NOTICE OF MEETING
PLANNING AND ZONING COMMISSION
6:00 P.M. – January 13, 2022

PLANNING AND ZONING COMMISSION ITEM:
PC-21-35
FINAL PLAT
Lux Tract Water Pumping Facility

PLANNING AND ZONING COMMISSION ITEM:
PC-21-36
REPLAT
Replat of Lot 69 & 70, Block 4, Belle Oaks Ranch
Phase I

SUBJECT: Lot 69 & 70 Replat Review
Belle Oaks Ranch Phase 1
PC-21-36

FINAL SUBDIVISION PLAT BELLE OAKS RANCH, PHASE IX

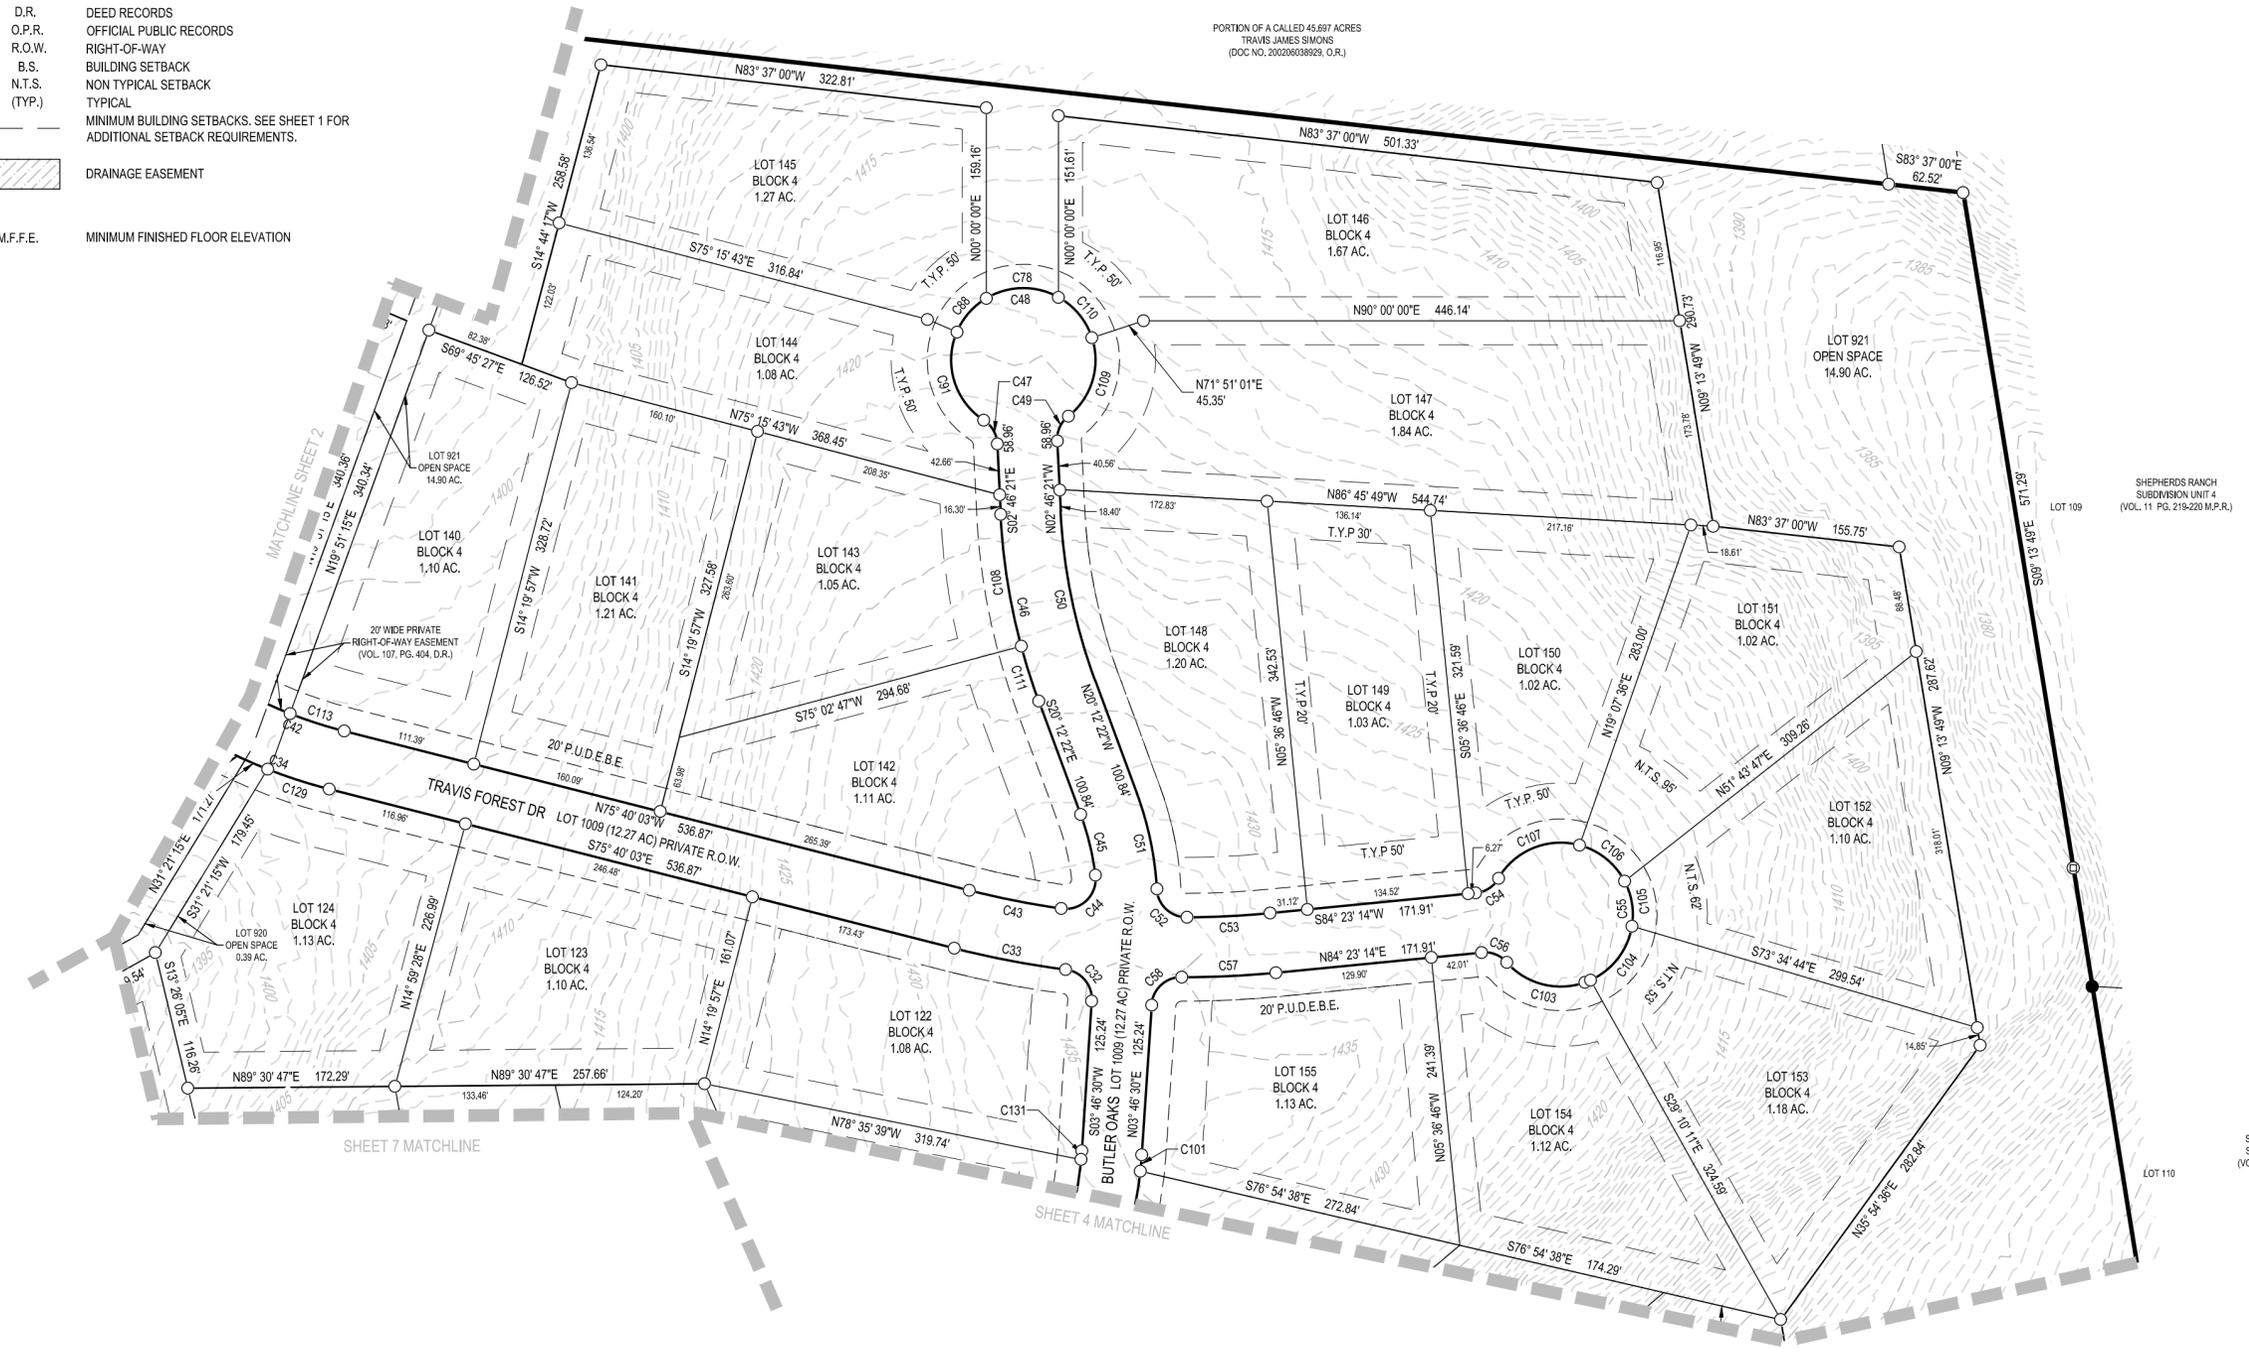
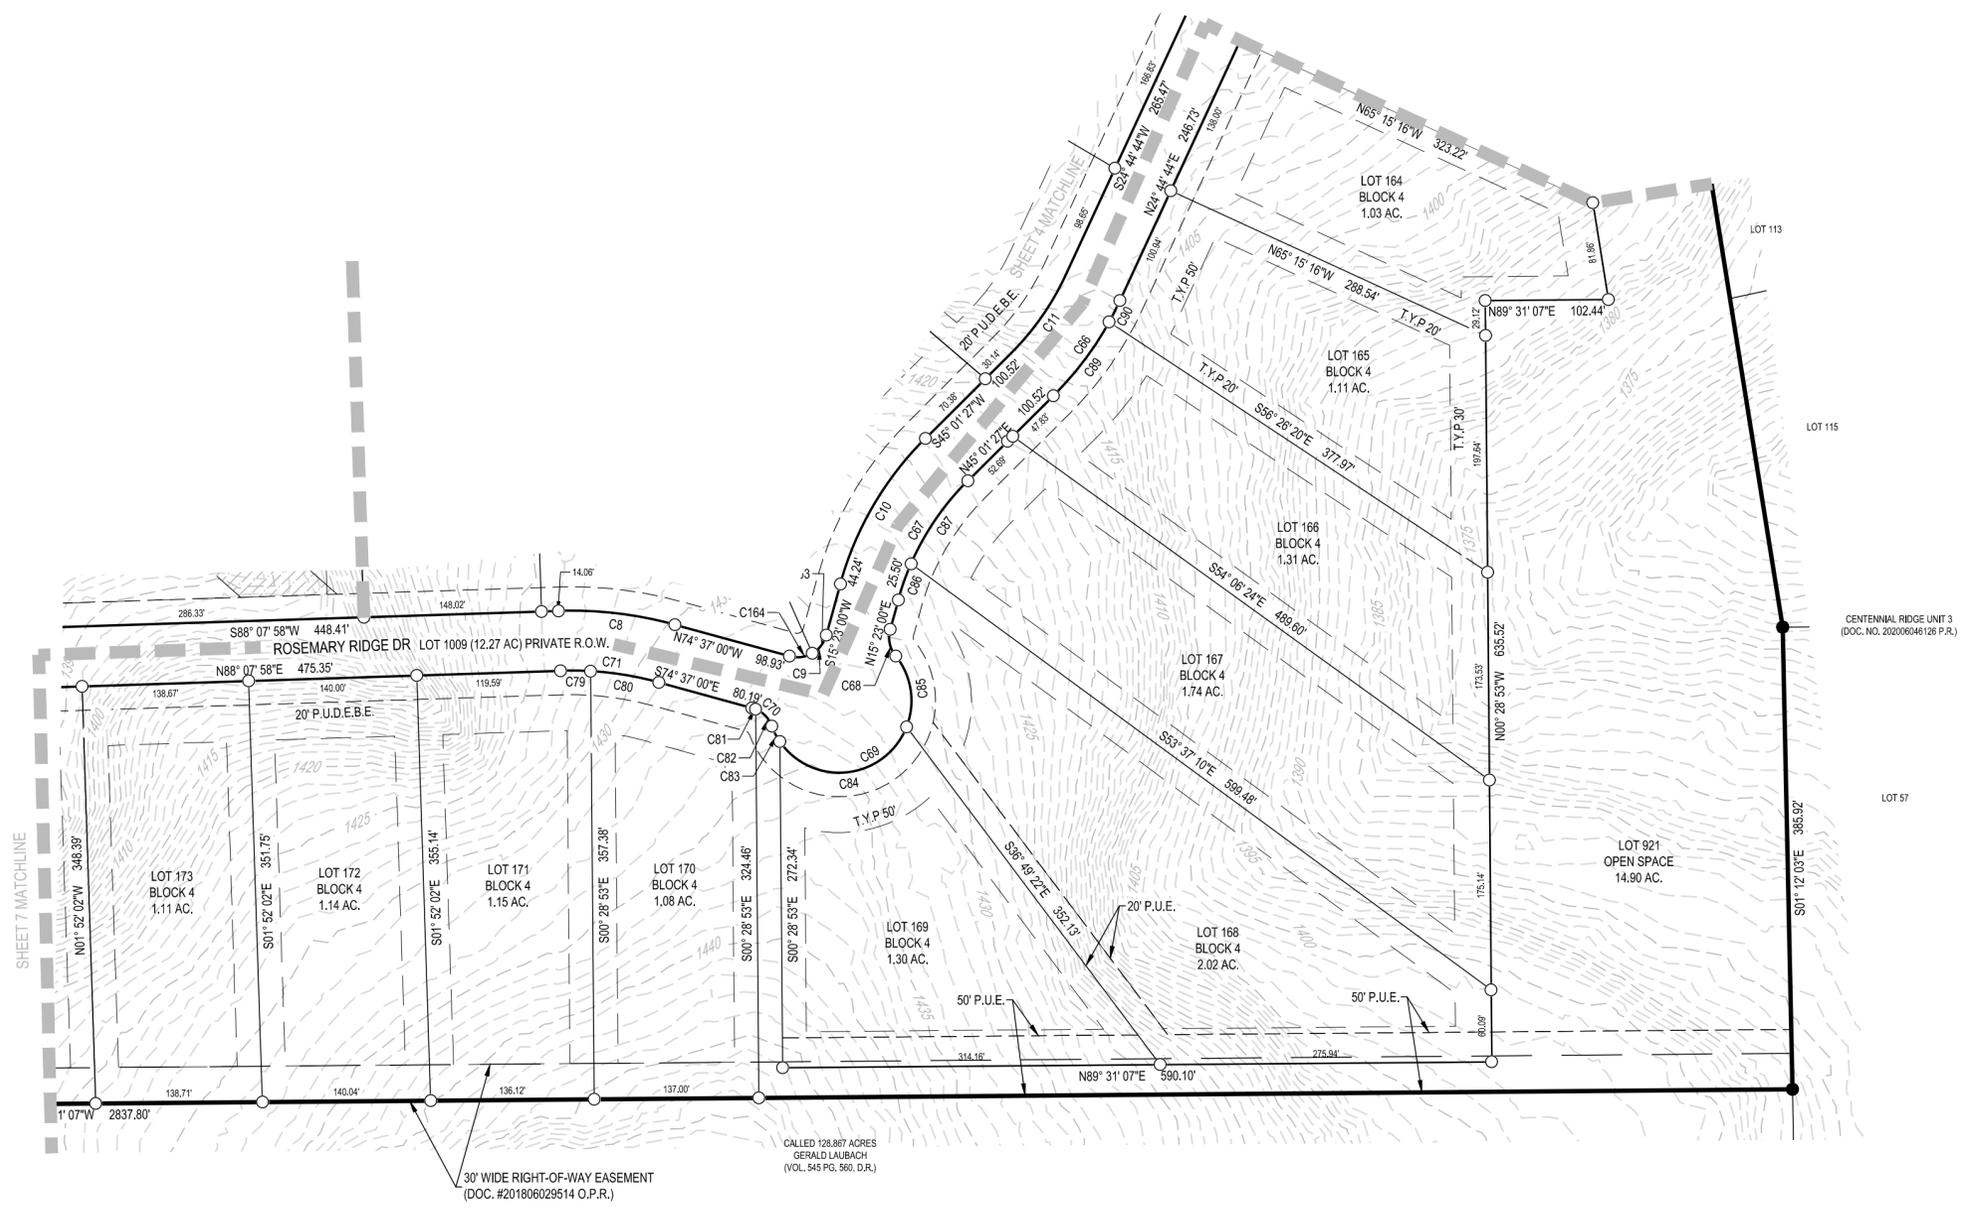
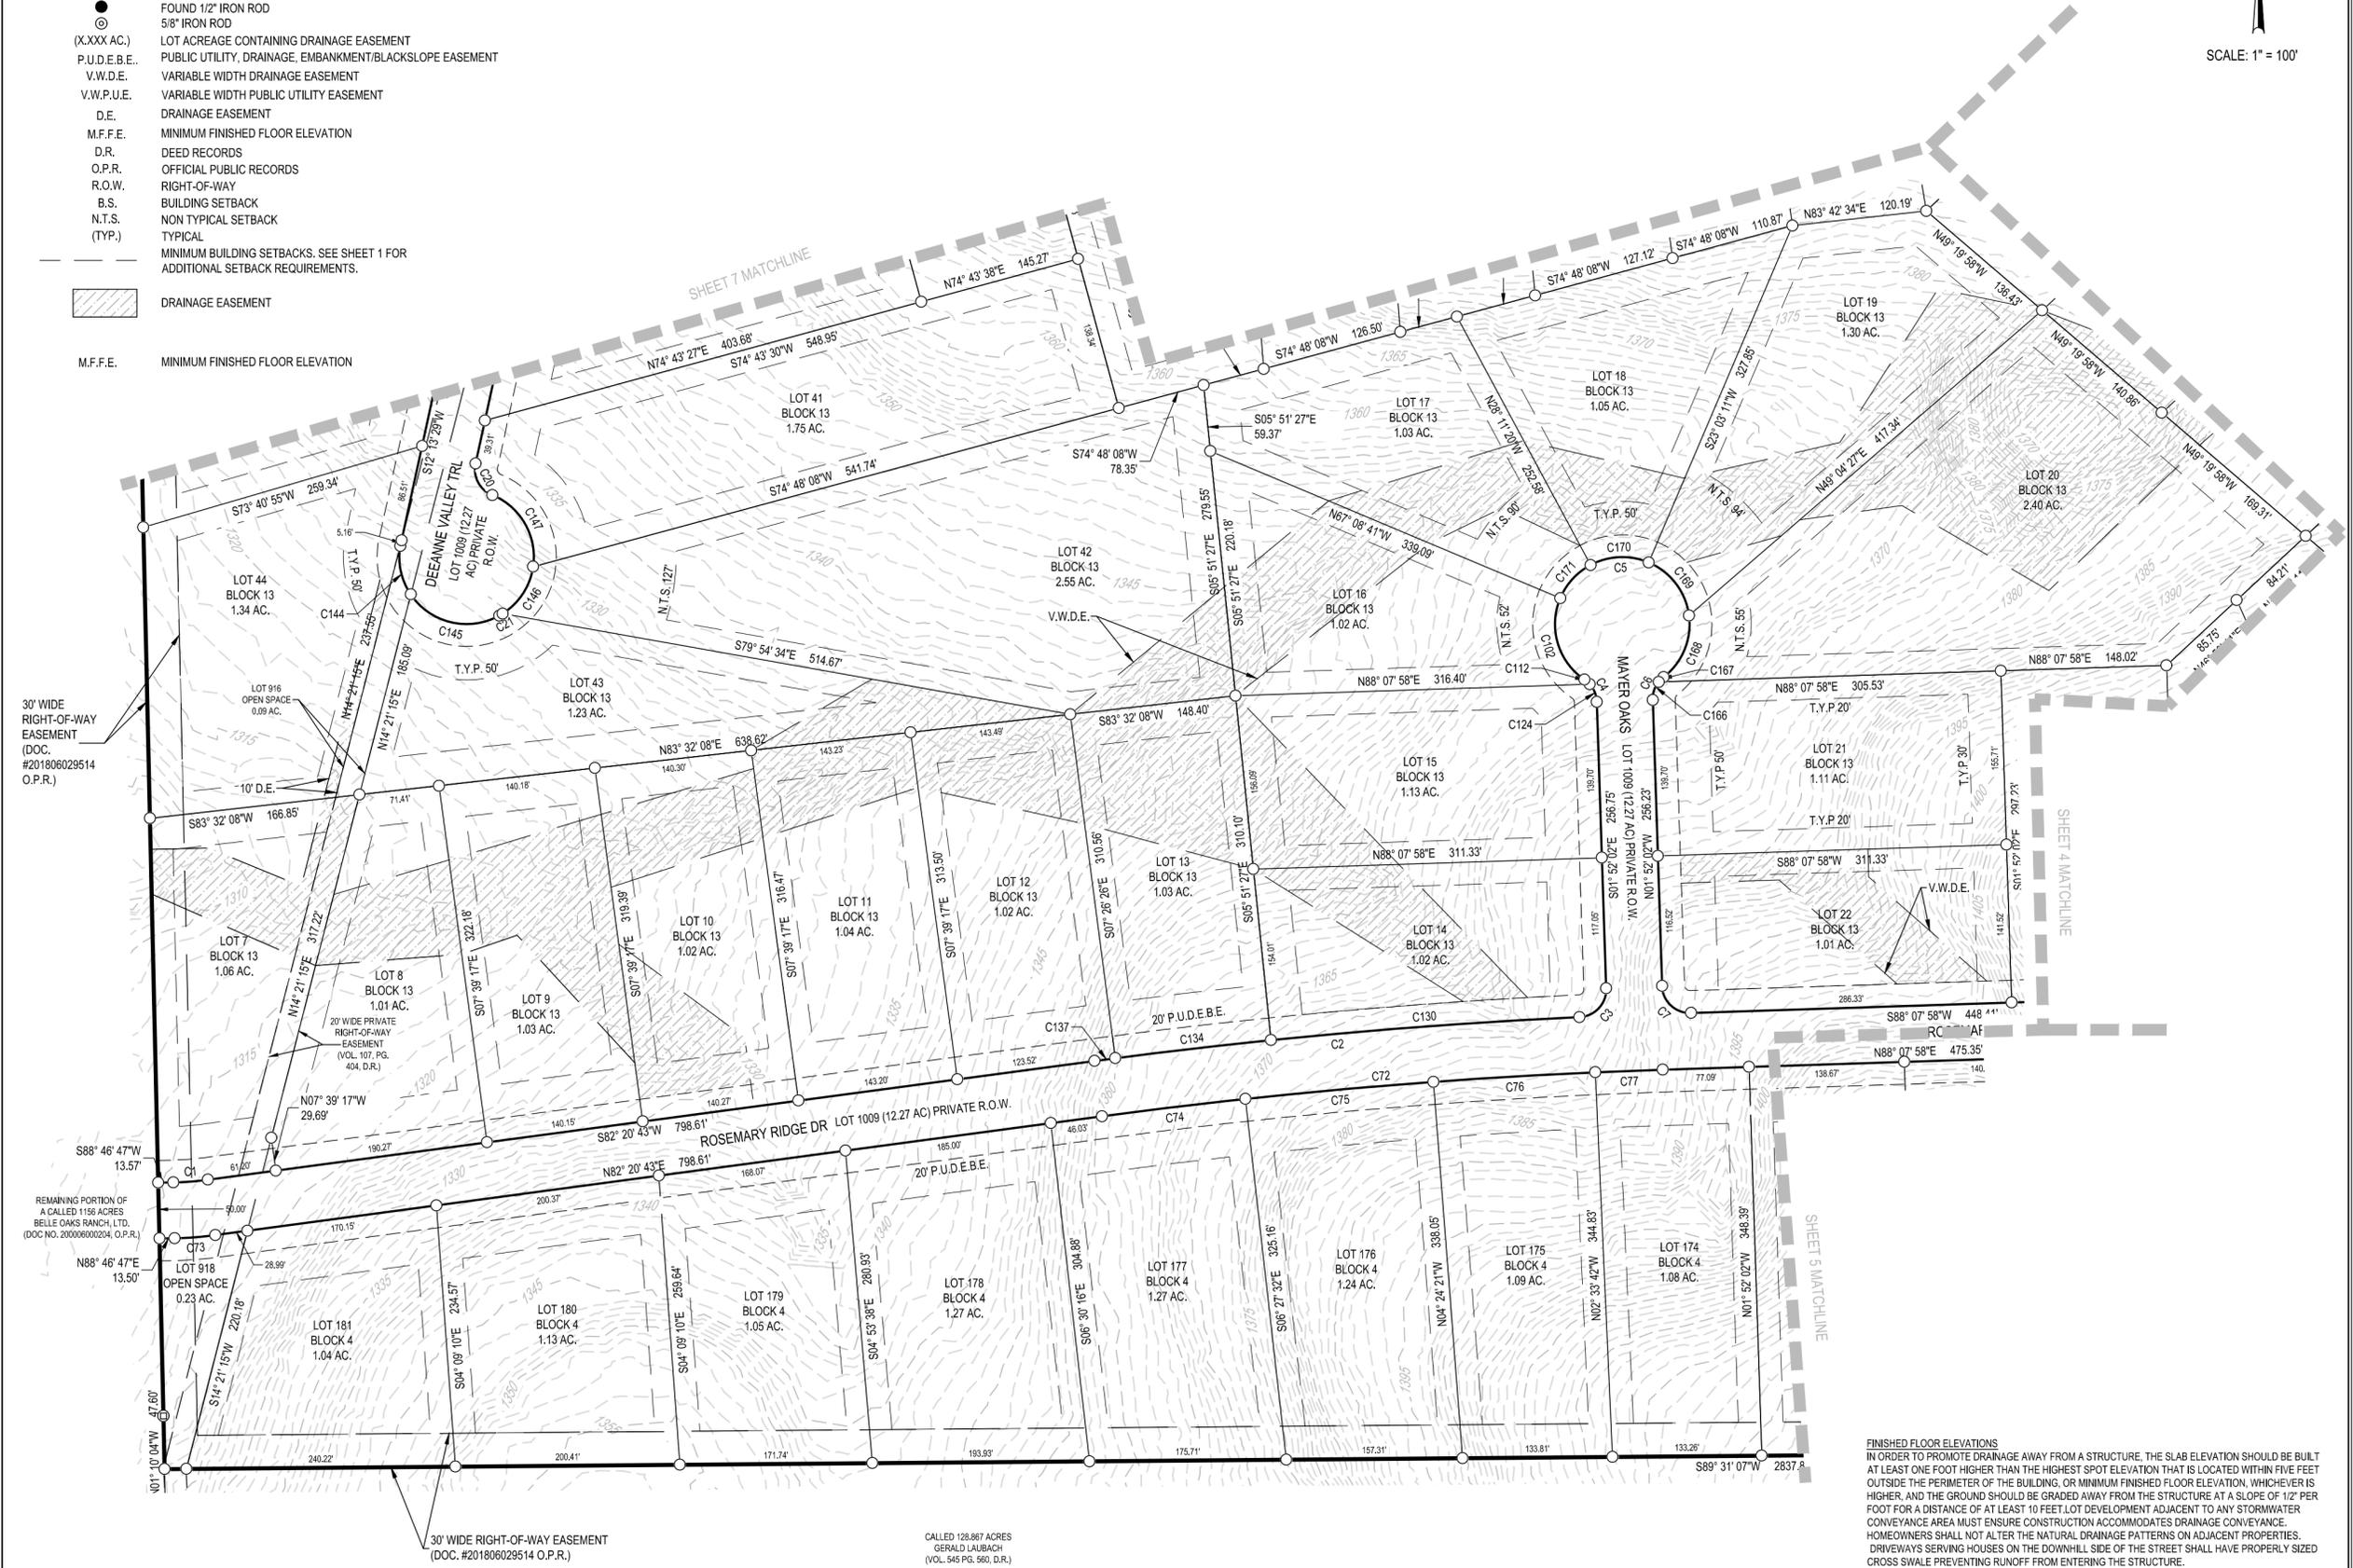
1. Provide a bearing and distance dimension from a corner of the subdivision to a corner of the original tract or original survey.
2. Provide a minimum of two corners of the subdivision referenced to State Plane Grid Coordinates.

3. This is an update to the March 16th report approved with the Phase 8 plat. Please provide updated HMS output.

1. Spelling:

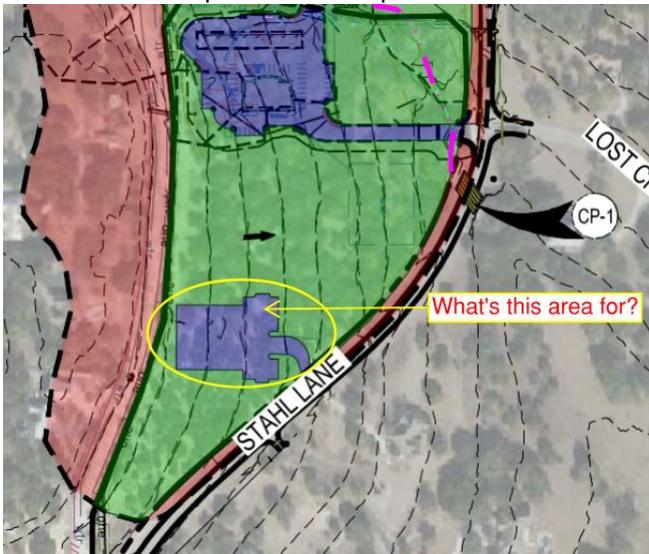
THE OWNER OF ^{THE} ~~TE~~ LAND SHOWN ON THIS PLAT WHOSE NAMES .

SHEET
C3.0

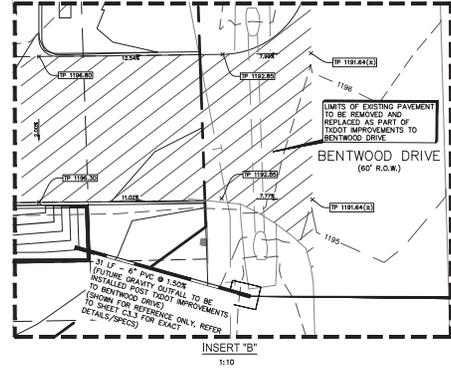
2. Cuts or other excavation associated with the preparation of land for development of lots and public improvements may not exceed four (4) feet in depth (City Code Section 4.05). The City Manager may approve a cut or fill of not more than 8 feet. Much of this development is cut more than 8 feet and will require a variance approval by City Council. 10/8 Comment: Cuts are still more than 4 feet and will require a variance approval by City Council. The only difference since plans dated 4/21/21 is the retaining walls were removed and replaced with a steep slope. Per response dated 11/19, the applicant is submitting a variance request. – [Comment resolved...a variance request was submitted, dated 12/01/21. After reviewing the design plans and variance request, Halff has no objections from a safety stand point as long as the proper fall protection is in place and steep slopes are stable. This area of development along Forty Six Pkwy from River Way to Bentwood Dr has all similar circumstances with the steep slopes and retaining walls in back of the commercial developments.](#)

5. Missing retaining wall analysis/design. Design plans by ALJ Lindsey acknowledge these plans must be provided by the contractor “via the chosen proprietary MSE system.” – [no comment required at this time, but this note is included as a reminder to the City to acquire the appropriate design plans prior to wall placement by the contractor.](#) 10/8 Comment: Retaining walls appear to have been removed, but steep slopes greater than 3:1 will need engineered concrete reinforcement. Response dated 11/19 says steep grading has been designed in conformance with geotechnical report to include shotcrete for slope stabilization. Need Geotech report to confirm.

- a. [Based on the Geotech report it appears the steep cut will take place near bore B1. Based on the log there is approximately 7 feet of soil over burden above the rock. Halff recommends they use a different approach to retain this soil before they get to the rock cut. The Geotech states the vertical cut is not allowed in the soil stratum. Please adjust the design plans.](#)

- b. [On the shotcrete, recommend weld wire fabric attached to the rock surface and then the shotcrete applied over that. This will help hold the shotcrete together \(standard practice with shotcrete application\). Please add to the details and notes.](#)

6. [Fall protection \(i.e. fencing/guardrail\) needs to be added along all drops steeper than 3:1 with falls greater than 4 feet. Please show on design plans with details.](#)
